Office Action Summary	Application No. 10/594,561	Applicant(s) TANIDA ET AL.	
	Examiner TERESA M. ARROYO	Art Unit 2826

DETAILED ACTION

FIG. 3H

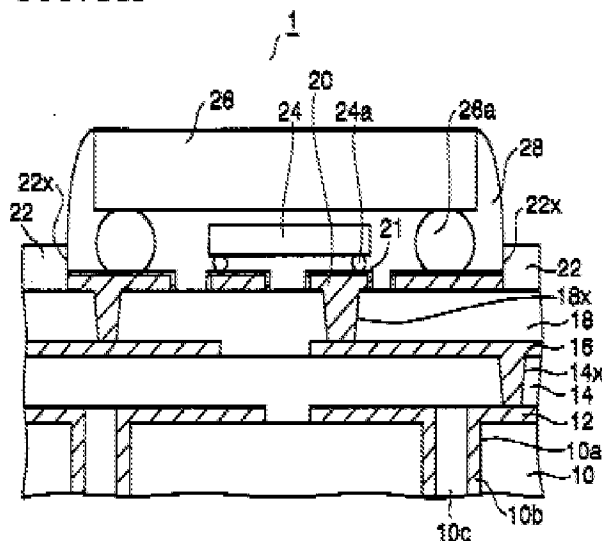
an insulating film 22 provided on the surface of the solid state device 10 facing the semiconductor chip 26, the insulating film 26 having an opening greater in size than the semiconductor chip 26 when the surface of the solid state device 10 facing the semiconductor chip 26 is viewed from vertically above; and

It appears that Fig. 3H below “when viewed from above” includes an opening between the edge of insulating film 22 and the edge of semiconductor chip 26 that is greater in size than the semiconductor chip 26 although there is no top view.

FIG. 2 (b)

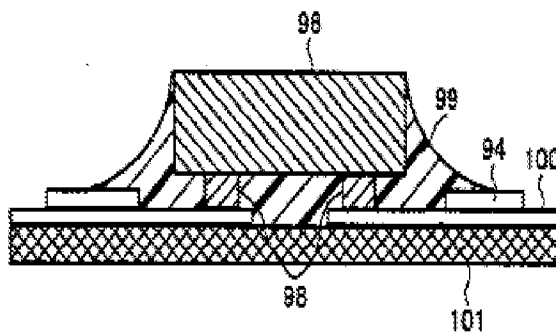
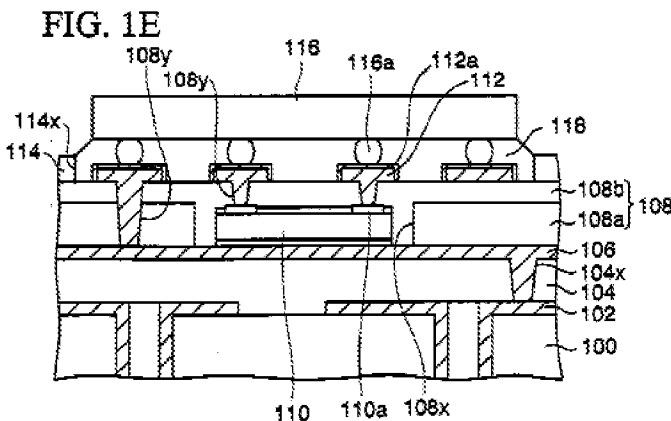
14. Toyosawa teaches a pillar-shaped connecting member 98 for connecting a semiconductor chip 96 and a solid state device 101. The width is constant at 24 μm in para. [0135]. Further, Toyosawa teaches a sealing layer 99.

15. Therefore, it would have been obvious to a person of ordinary skill in the art at the time the invention was made to use a pillar-shaped connecting member having a constant width in Sunohara such as taught by Toyosawa in para. [0046] since determining the optimum shape/width would have only involved routine skill in the art as discussed in the legal precedent below.

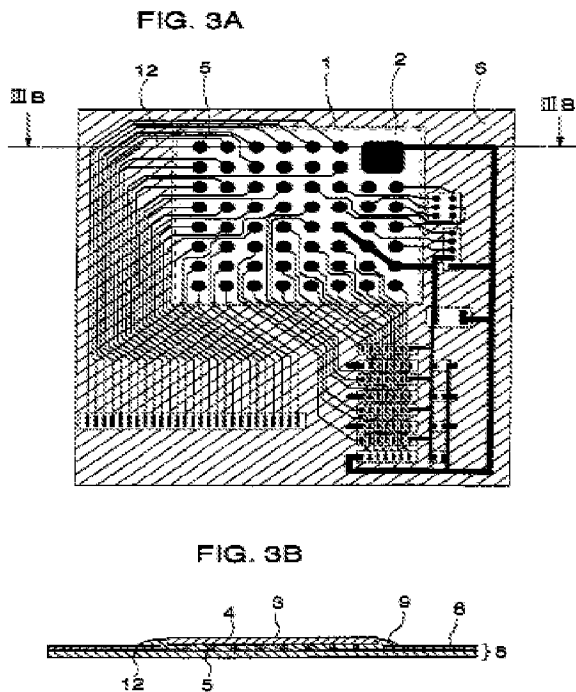
27. Regarding claim 14, it appears that Toyosawa teaches wherein the solder resist 94 has a thickness smaller than an interval between the semiconductor chip 96 and a surface of the solid state 101 device opposing thereto, the solid state device 101 being a wiring board.

FIG. 2

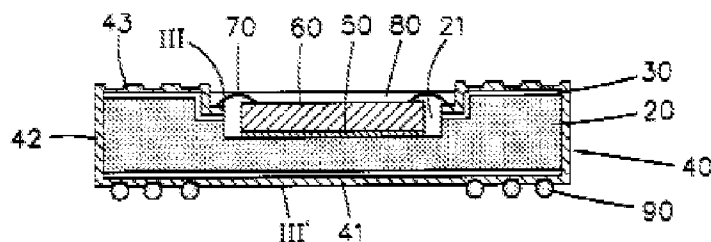
34. Lee teaches an electrode 42 formed at an end of a wiring board 20.

35. Therefore, it would have been obvious to a person of ordinary skill in the art at the time the invention was made to use an electrode at an end of the wiring board in the modified device of Sunohara to manufacture a package with multiple layers of semiconductor packaged as taught by Lee in the Background.
